GROUP	MODEL
BOD	2025MY Sorento (MQ4a)
NUMBER	DATE
332	September 2024

TECHNICAL SERVICE BULLETIN

SUBJECT: SERVICE ACTION: DOOR BELT OUTSIDE WEATHERSTRIP REPLACEMENT (SA589)

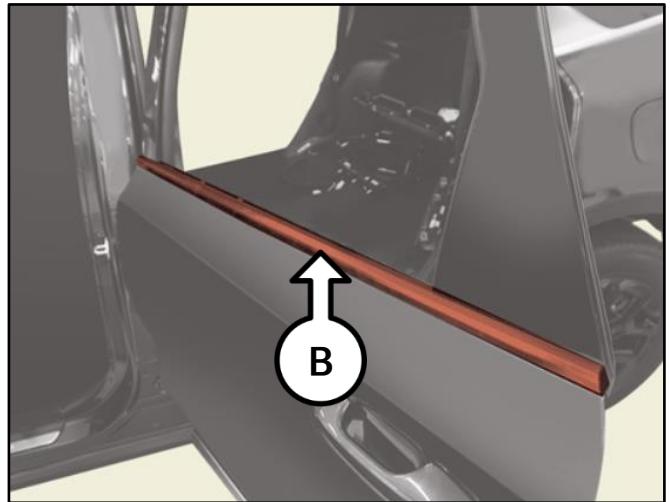
1. Replace both Front Door Belt Outside Weatherstrips (A) by referring to "Body (Interior and Exterior) → Door - Front → Front Door Weatherstrip → Repair procedures" in the applicable Shop Manual on KGIS.

2. Replace both Rear Door Belt Outside Weatherstrips (B) by referring to "Body (Interior and Exterior) → Door - Rear → Rear Door Weatherstrip → Repair procedures" in the applicable Shop Manual on KGIS.
